MILWAUKEE METRO CENTER
AMENDED DETAILED PLANNED DEVELOPMENT
BERGSTROM AUTOMOTIVE
PROJECT: Description and Owner's Statement of Intent
REVISIONS ARE NOTED IN BOLD PRINT
JUNE 1, 2004

AMENDED STAGE ONE DETAILED PLANNED DEVELOPMENT
BERGSTROM GOLDEN EAGLE DEALERSHIP

REVISED
CHANGES TO AMMENDMENT
6/1/2004

EXHIBIT 4
REVISED
CHANGES TO AMMENDMENT
6/1/2004

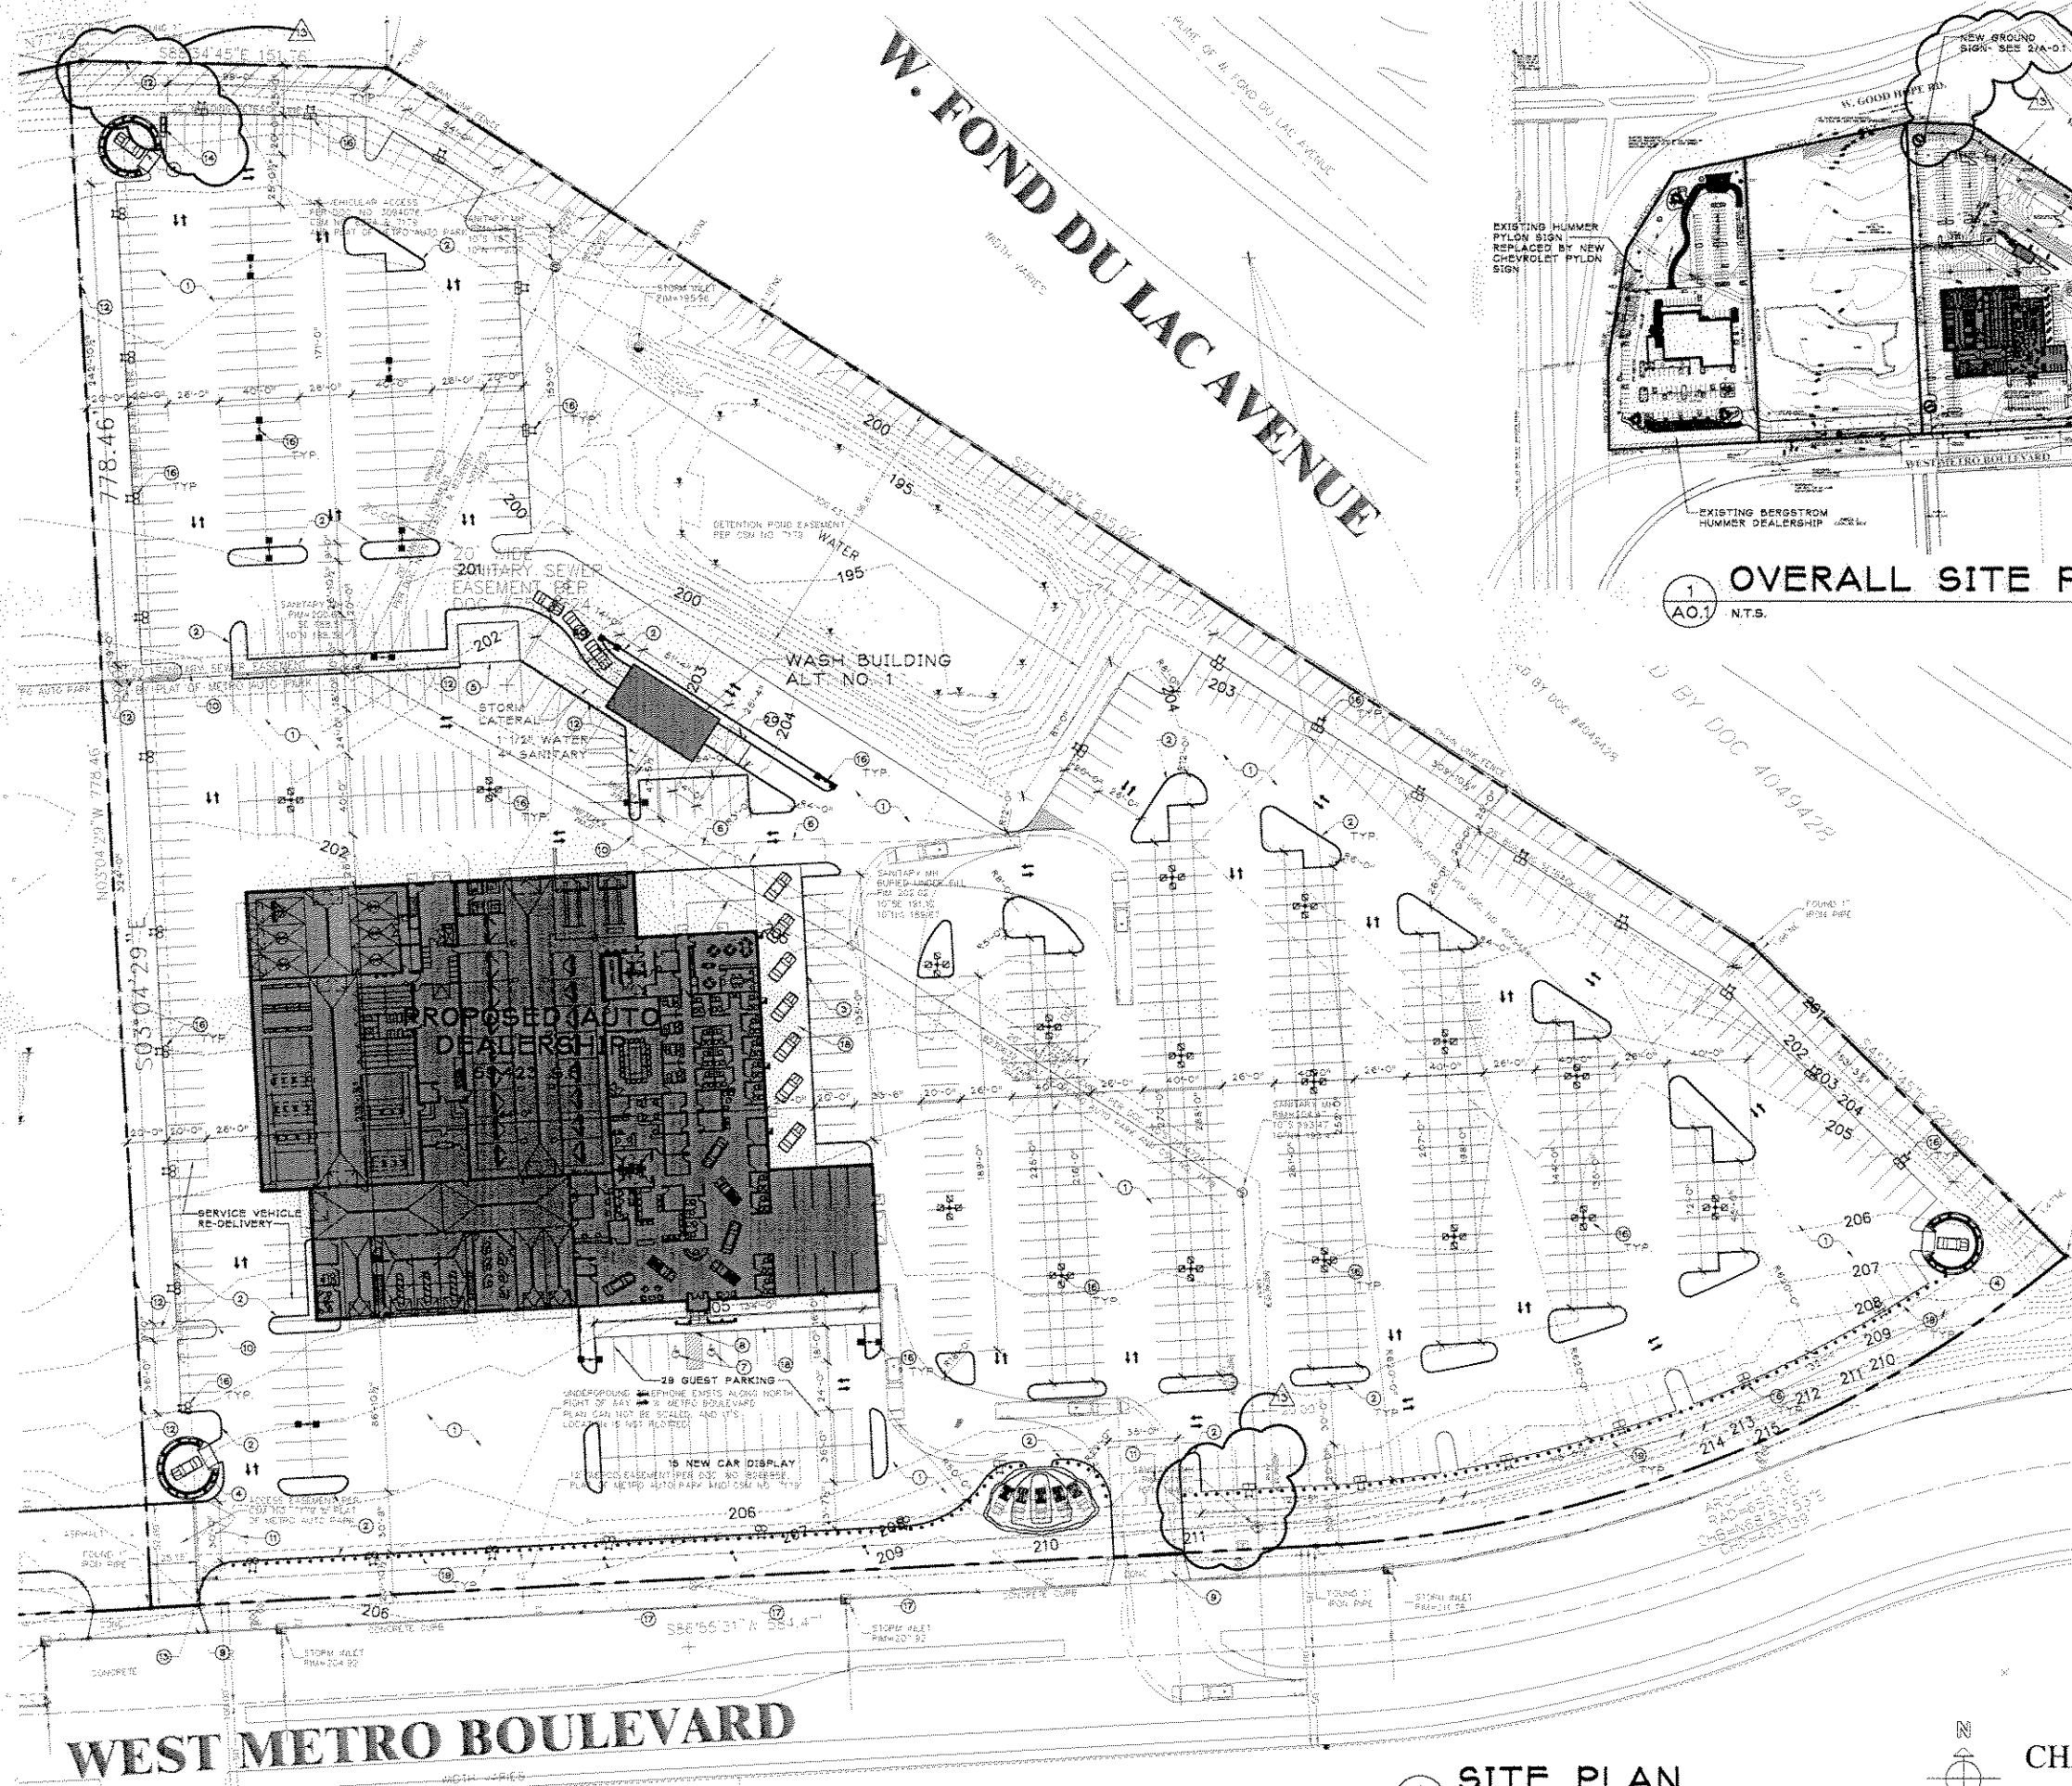
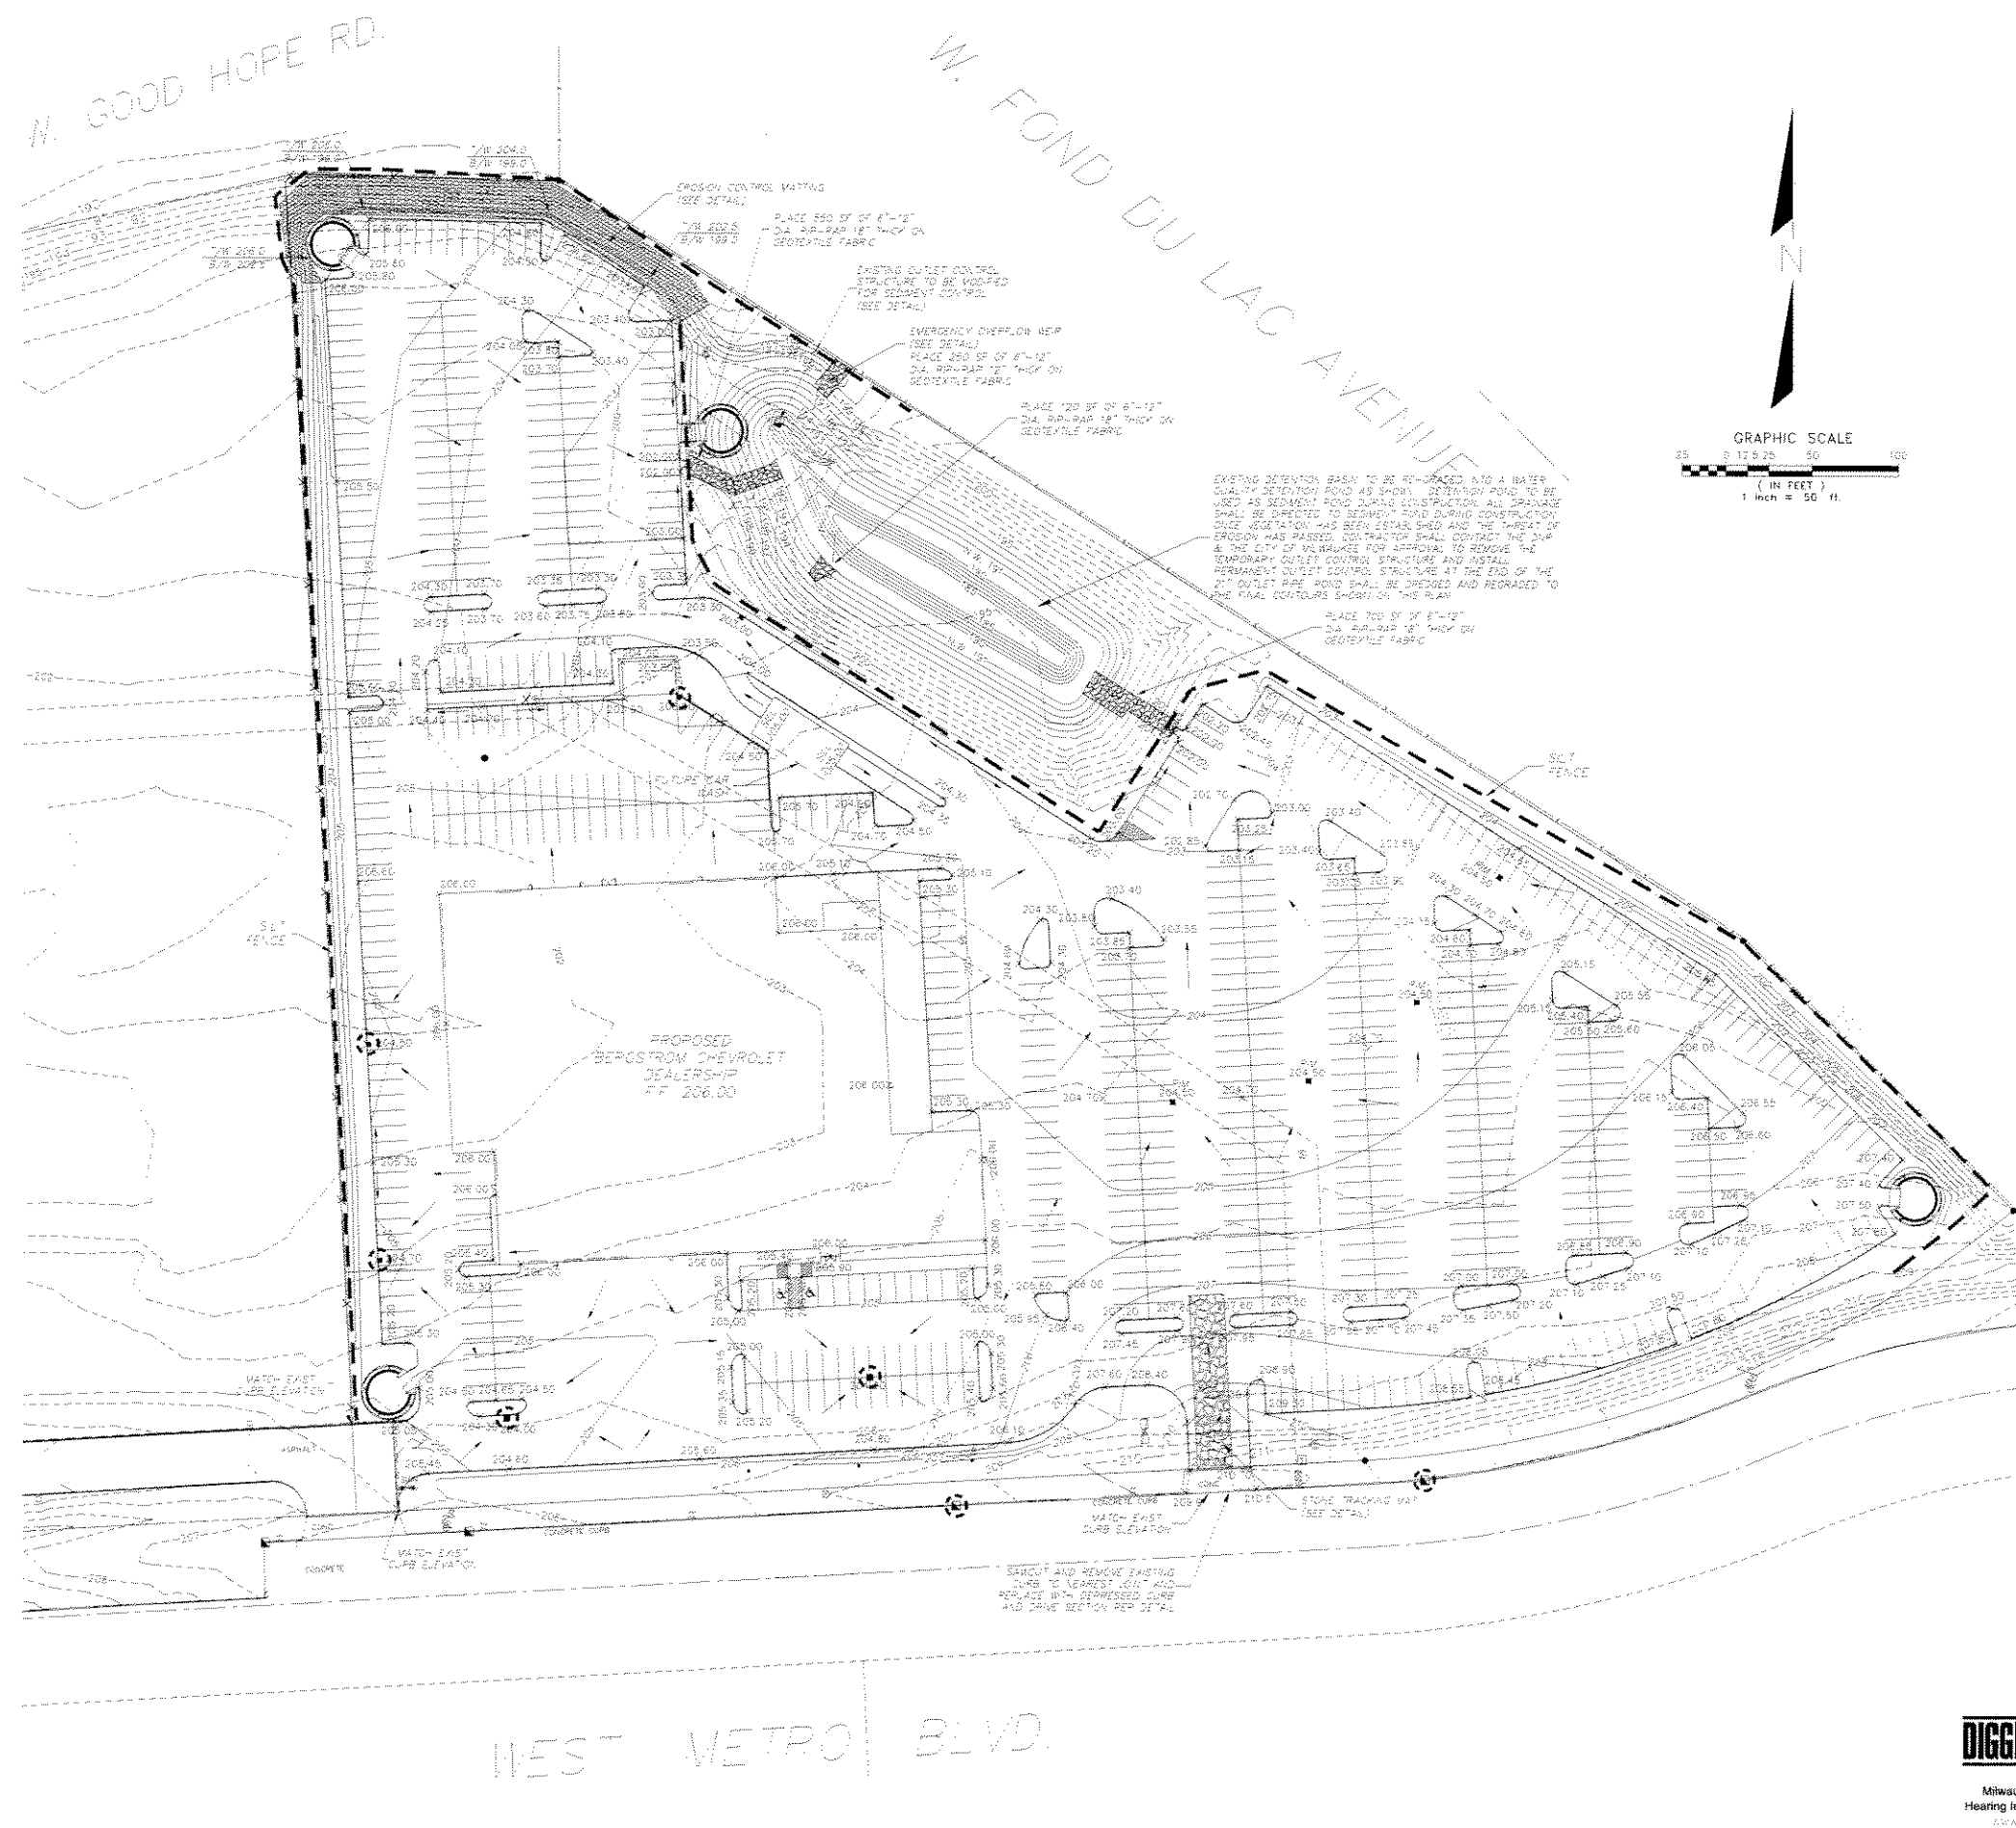
4. Except for a grand opening to be approved by the City, no balloons, flags, pennants, streamers, spinners, tinsels, or other similar devices, or any signs other than those contained in **Exhibit "4"** and on **Sheet A-1.2** shall be applied to any building or structure or strung on wires or otherwise used on site.

- G. Signage – Signage is described and located on Exhibit "4". **Building Signage will be individual internally illuminated, plastic faced light bar, metal sided letters. Chevrolet sign replacing existing HUMMER sign is internally illuminated, channel letters. New 18' high pylon sign at northwest corner of property will be internally illuminated, a type "A" sign with channel letters and logo cut into metal panel frame. Pylon will be on steel standards covered with aluminum panels. The 24' Chevrolet pylon sign has**

been approved prior to this amendment. The 18' Chevrolet pylon sign will require an amendment to the existing general and detailed plan for the Bergstrom Chevrolet site. This amendment is being submitted for Common Council's review. Signage will meet all requirements of S 295 and CH 244
